USNRC APPLICATION
SUA-1341 License Amendment
Ludeman Project
Converse County, WY

June 2013

0 0.75 1.5 3 Miles

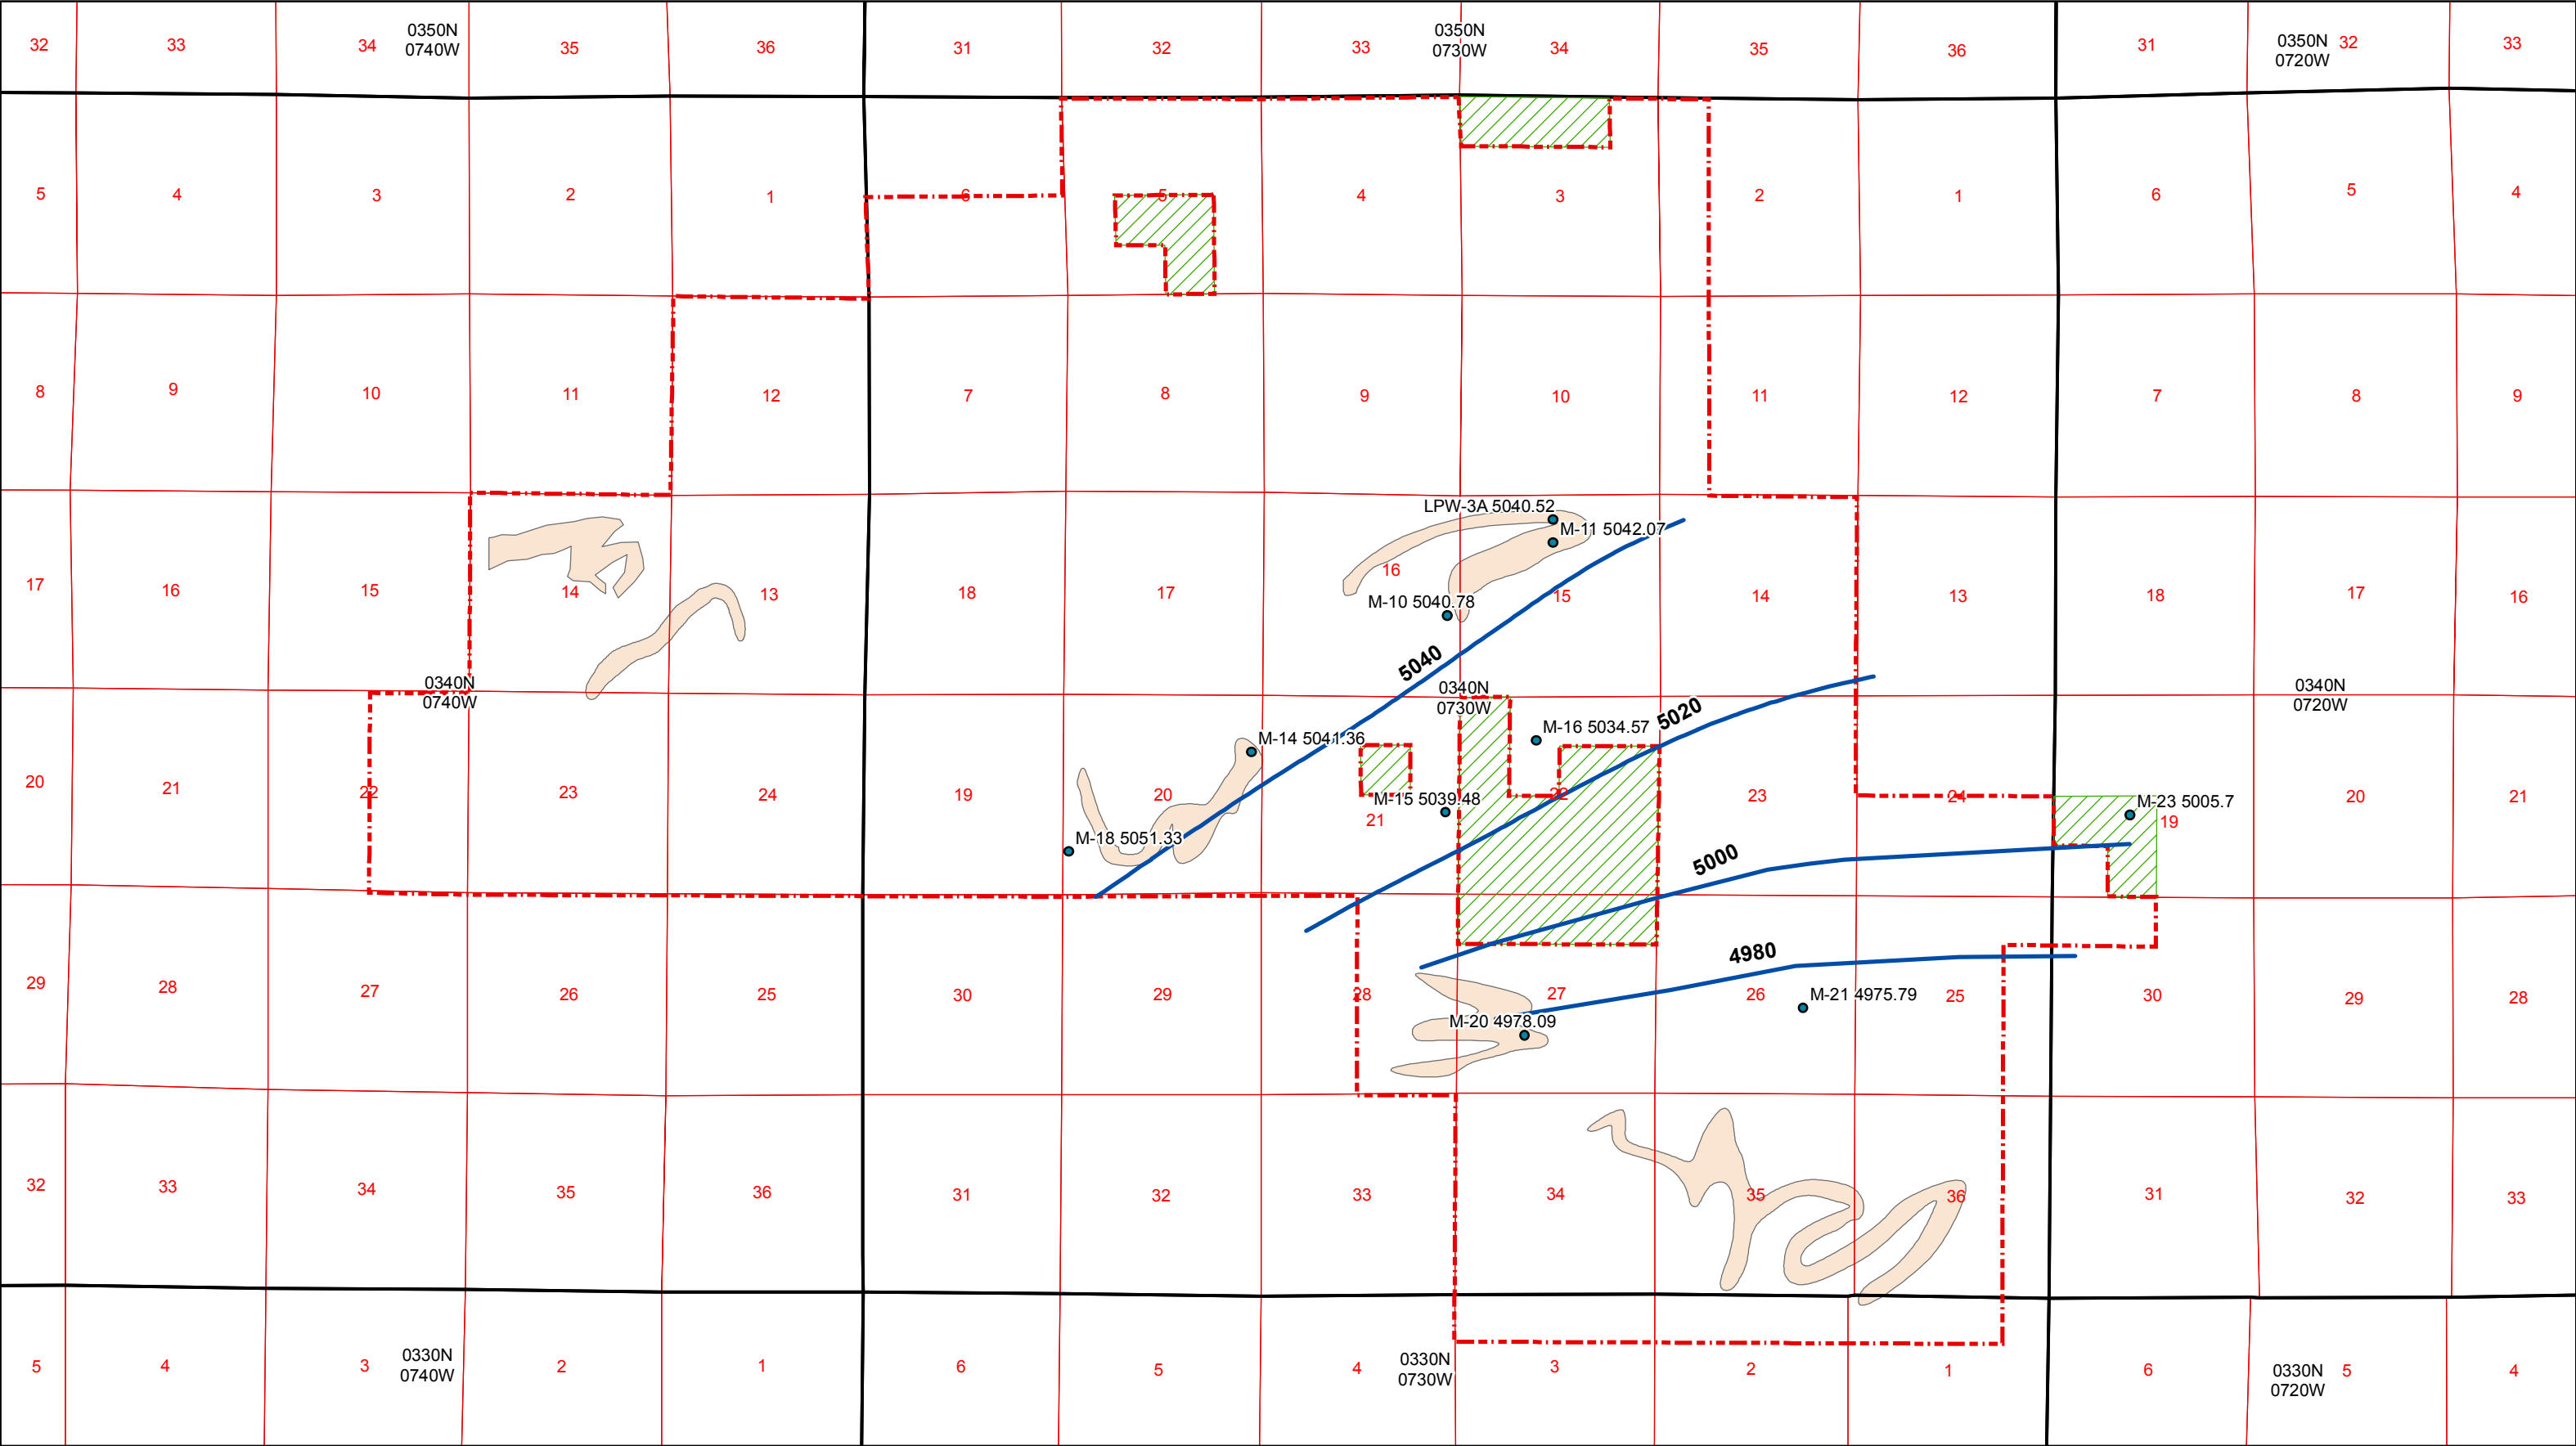
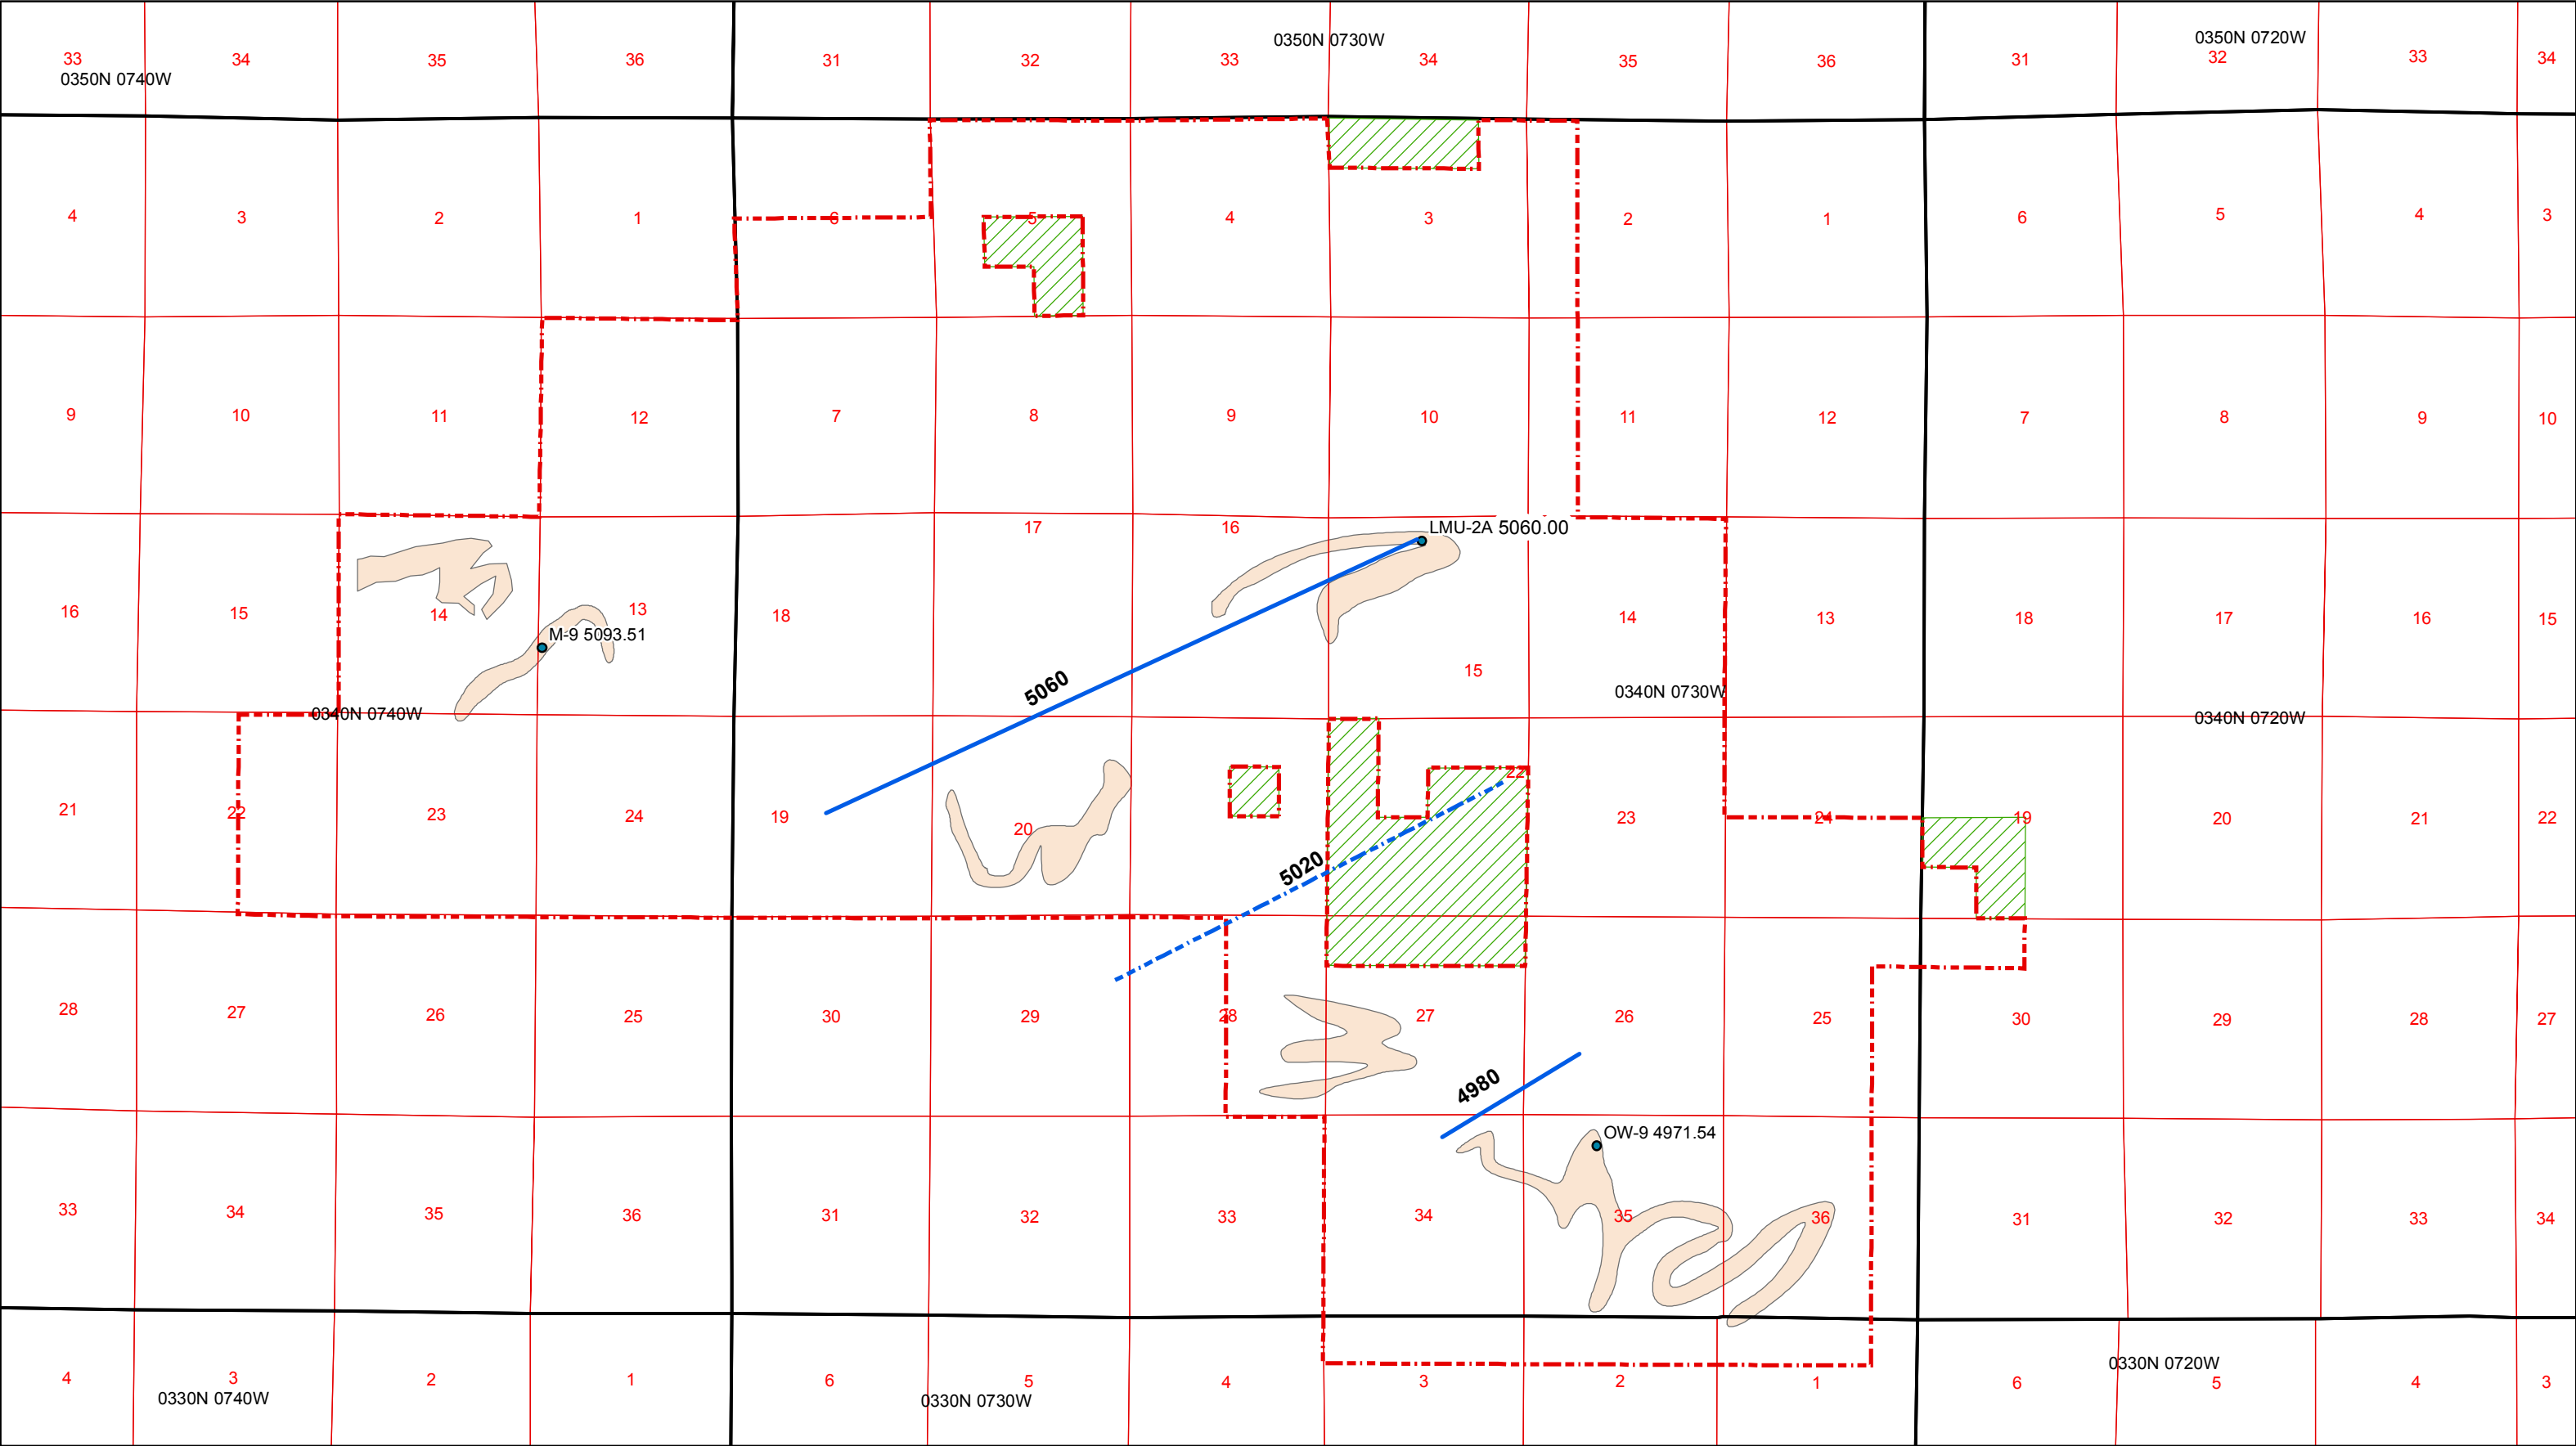
Staff evaluated the Addendum 2.7-C table “Summary of Monitoring Well Completions” and found the majority of the well top of casing (TOC) elevations in the tables were in conflict with well log ground surface elevations of the same wells provided in the cross sections in Figures 2.6-3 through 2.6-13. The table below presents the monitoring well top of casing elevations provided Addendum 2.7-C vs. the elevations provided on the cross sections. As can be seen in the table, there are often very large differences in the elevations. These differences call into question the aquifer water levels in mean sea level which were calculated based on the top of casing elevation. These water elevations are the basis for the potentiometric surfaces created for all the aquifers in the proposed license area. In addition, the selection of aquifer sand location is questionable if the well TOC elevation is inaccurate. Because of these errors, staff was unable to evaluate the potentiometric surfaces, ground water flow direction and magnitude for the Leuenberger, North Platte or Peterson Satellites. Staff is also unsure if Uranium One has made the appropriate identification for the location of the underlying sands and aquitards based on the elevation errors. Staff cannot evaluate or provide reasonable assurance for the safety of operations at any of the proposed satellites without correction of the elevations of these monitoring wells and all figures and calculations (e.g. sand top and thickness) which were based on them.

Uranium One should correct all monitoring well elevations noted to be in error on the table and correct all discussions, tables, maps, cross sections and isopachs which used the incorrect elevation information from these monitoring wells. In addition, Uranium One should ensure that all well surface elevations presented in the application are accurate and all calculations based on them are also accurate. Staff is especially concerned about the correction of the elevation of the overlying aquifer sand, ore zone aquifer sand, underlying aquifer sand and associated aquitards at each satellite.

Additionally, staff is very concerned about the potentiometric surfaces and vertical gradients between aquifers which were calculated based on these elevations. Staff notes that anomalous potentiometric surface mounds were associated with some of these elevation errors. Therefore, once corrections are made to the elevations, provide the corrected potentiometric surfaces and estimate the ground water flow magnitude and direction for all overlying aquifers, ore zone aquifers and underlying aquifers for the Leuenberger, North Platte, and Peterson Satellites. Uranium One should use available water levels from wells located within 2 km of the each satellite's proposed wellfields for these updated surfaces, not just the limited monitoring wells available to provide better estimates of ground water flow direction and magnitude.

Uranium One has updated the well elevations presented in Addendum 2.7-C Summary of Well Completions with survey data and subsequently the potentiometric maps. For the wells that did not have survey data available, NED elevations have been utilized. The review of the NED elevations versus the survey elevations showed that the NED data were quite close. Thus, in cases when new survey data were not available, the NED data should provide a good approximation of elevation. The cross sections and isopachs will not require updates as they utilized the survey data to develop the figures.

The updated potentiometric maps are shown below.
